# TECHNICAL SERVICE BULLETIN

Technical Service Bulletin: 225-1717

Forest River is alerting you to an issue involving certain 2018-2023 Coachmen Galleria Class B Motorhome Recreational Vehicles. Please see the information below, which describes the issue and provides you with details on the steps you should take to have your vehicle repaired.

Concern:  
The battery boost was erroneously wired with the power steering.

FIG. 1

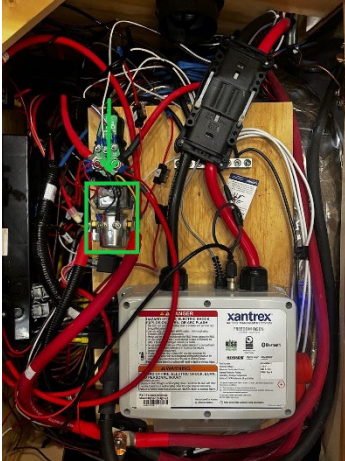
STEP 1: LOCATE AND ACCESS THE COMBINER SOLENOID AND RELAY IN THE MAIN ELECTRICAL COMPARTMENT) (FIG 1.);

FIG. 3

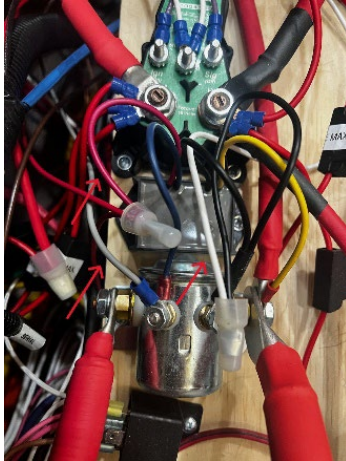
STEP 3: CUT/DISCONNECT COMBINER RELAY *RED* 16 AWG WIRE FROM HARNESS - (RECONNECT *RED* 16 AWG AND *RED* 16 AWG IN HARNESS) (FIG. 3);

FIG. 3B

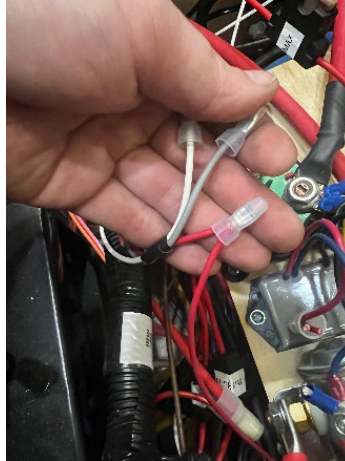
3B. CUT/DISCONNECT COMBINER RELAY *BLACK* 16 AWG WIRE FROM *WHITE* 16AWG WIRE - (CAP OFF *WHITE* 16 WIRE) (FIG. 3B);

FIG. 4

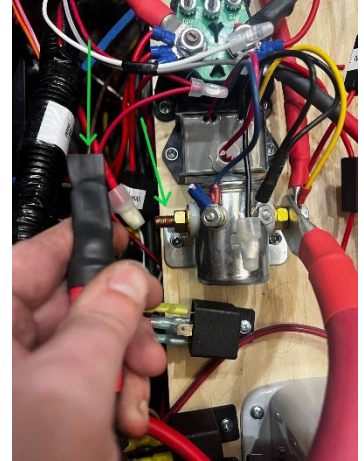
STEP 4: USING A 1/2" SOCKET REMOVE THE *RED* 2 AWG CHASSIS BATTERY CABLE CONNECTED TO THE COMBINER SOLENOID (FIG. 4);

4A. APPLY HEAT SHRINK OVER THE TERMINAL OF CABLE USING HEAT GUN;

FIG. 5

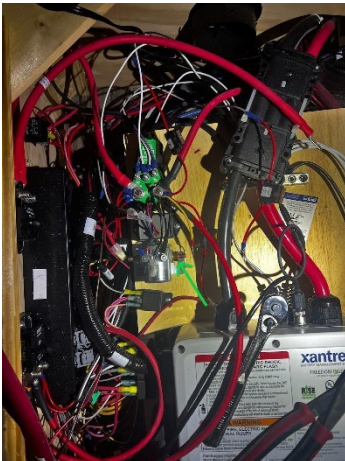
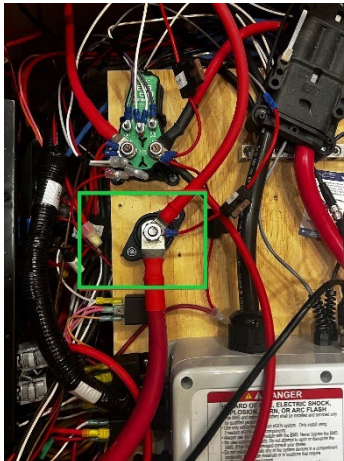
STEP 5: USING A 1/2" SOCKET REMOVE THE *RED* 4/0 AWG HOUSE BATTERY CABLE, *RED* 2 AWG CABLE, AND IN-LINE FUSE HOLDER FROM

SOLENOID (FIG. 5);

FIG. 3

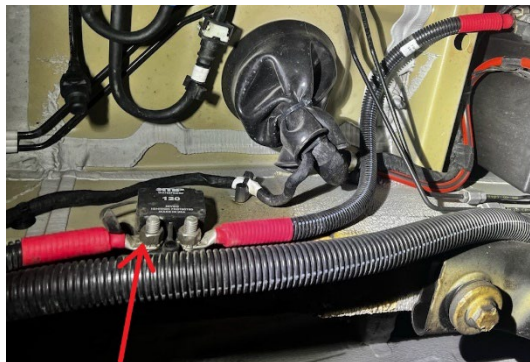
STEP 3: REMOVE THE RED 2 AWG CABLE CONNECTED TO THE AUXILIARY SIDE OF THE BREAKER USING A 9/16" SOCKET (FIG. 3);

3A. APPLY HEAT SHRINK TO THE END OF CABLE USING HEAT GUN;

FIG. 4A

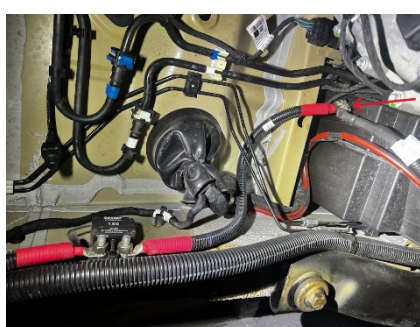
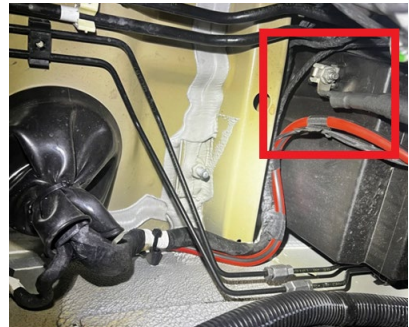
4A. REMOVE ZIP TIES OR CLAMPS RESTRICTING THE CABLE TO THE OEM TERMINAL POSTS (FIG. 4A);

FIGURE 2

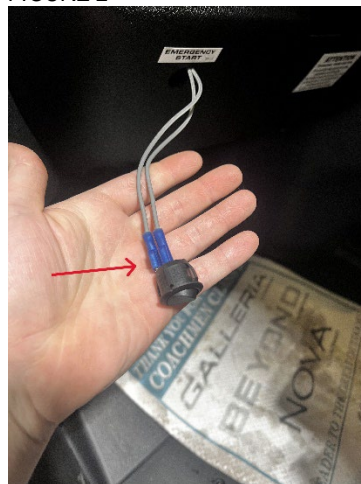
STEP 2: USING THE PRY TOOL, PULL THE SWITCH OUT FROM THE DASH AND DISCONNECT THE SWITCH FROM THE GREY 16 AWG WIRES (FIGURE 2);

FIGURE 3

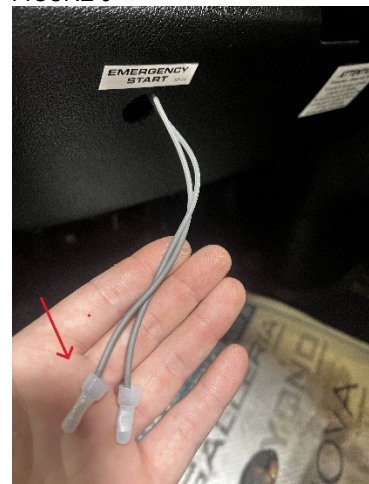
STEP 3: CAP OFF BOTH GREY 16 AWG WIRES AND TAPE TOGETHER (FIGURE 3);
